WHITE FARM EQUIPMENT

Service Bulletin

File: GO-40-101 (Rev. 1)

Subject: Mallory Distributor 1550,1650,1750,1850, 1555,1655,1755,1855, and 2-70 Tractors

DISTRIBUTOR

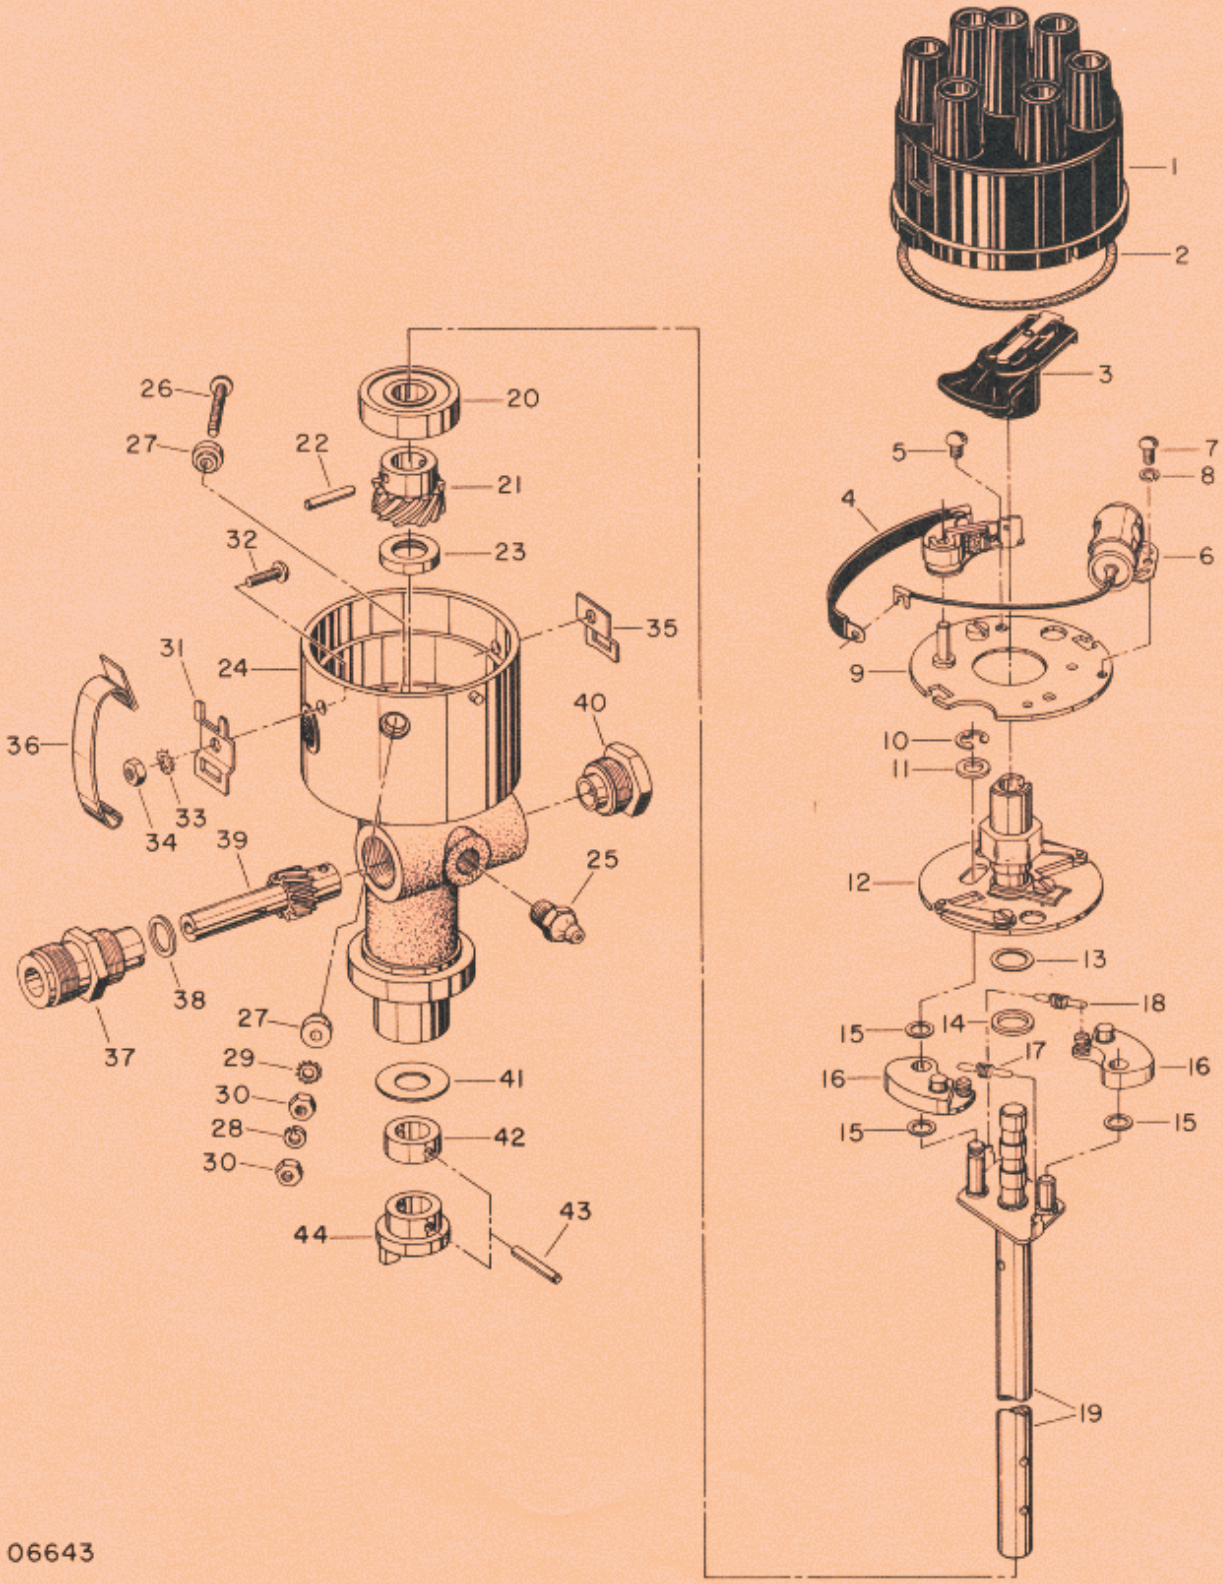
30-341 7778 Distributor (Mallory No. YL666A) replacing 30-318 6601 Distributor (Mallory No. YL620A), is being provided as repair replacement for 158 859AS Distributor (Holley), used on 1550, 1650, 1750, 1850 and some 1555, 1655, 1755, 1855 and 2-70 tractors.

New Mallory distributor uses only centrifugal advance. Replaced Holley distributor uses both vacuum and centrifugal advance mechanisms.

Additional repair parts information covering Mallory distributors can be found on page 2 and 3 of this bulletin.

1. When installing Mallory distributor in place of Holley distributor, remove and discard following parts:

2. Install 941 047 Plug in intake manifold vacuum line port.

3. Adjust distributor to following specifications:

Breaker Point Gap	.022
Dwell Angle at 2000 Engine RPM	32-36 Degrees
Ignition Timing:	
Static	0 Degrees
2200 Engine RPM	21° BTDC
